SUBJECT: Provides response to request for addl info re topical rept
 NTH-TR-01, "RETRAN Model Qualification - Decrease in Heat
 Removal by Secondary Sys."

Subject: Response to Request for Additional Information
Related to Topical Report NTH-TR-01, RETRAN Model
Qualification - St. Lucie Plant Unit Nos. 1 and 2
and Turkey Point Plant Unit Nos. 3 and 4 (TAC Nos. M75082,
M75083, M75084 and M75085)

QUESTIONS # 1 AND 2

FIGURE 2. RCS TEMPERATURES

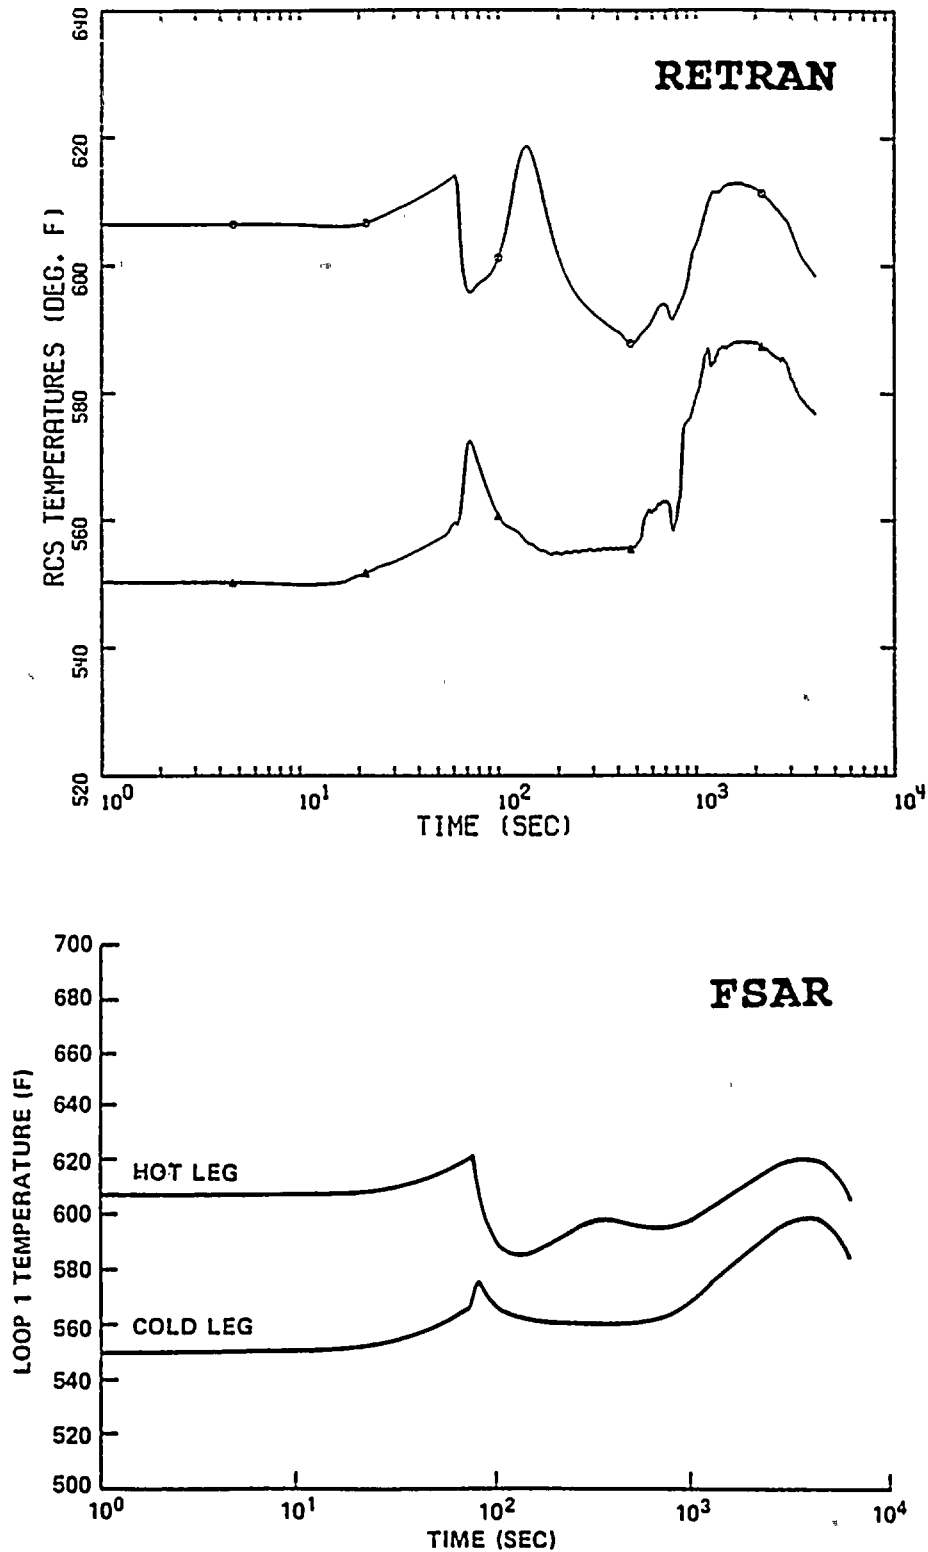
The Turkey Point Loss of AC Power transient included in Reference 1 has been reanalyzed with the following three modeling techniques evaluated during the plant event benchmark analysis.

- Slip
- More nodes in the steam generator lower tube bundle region
- Temperature Transport Delay option

The first two changes provide an improved distribution of the liquid mass in the steam generator and result in a more realistic prediction of the heat transfer and dryout time. Without these two options predicted dryout times are too early and heat transfer is too high.

Inclusion of these modifications in the Loss of AC Power analysis results in a calculation that is more conservative than the one presented in Reference 1 and is in closer agreement with the vendor analysis of this event (Reference 8). The majority of the input assumptions in both the FPL and the vendor analyses are the same (Reference 9). However, the analytical methods to simulate the event are different. The vendor methodology uses a single node steam generator model with an artificial representation of the heat transfer between primary and secondary to yield conservative results. The FPL methodology, as revised here, is based on the RETRAN code with an expanded multinode representation of the steam generator to better represent the fluid conditions in the lower tube bundle region. Comparisons between the vendor and the RETRAN results are shown in Figures 2 through 5 and Table 1. The results of the revised analysis do not change the conclusion from the original analysis (Reference 1), that the RCS can be successfully cooled with only one auxiliary feedwater pump without taking the pressurizer water solid.
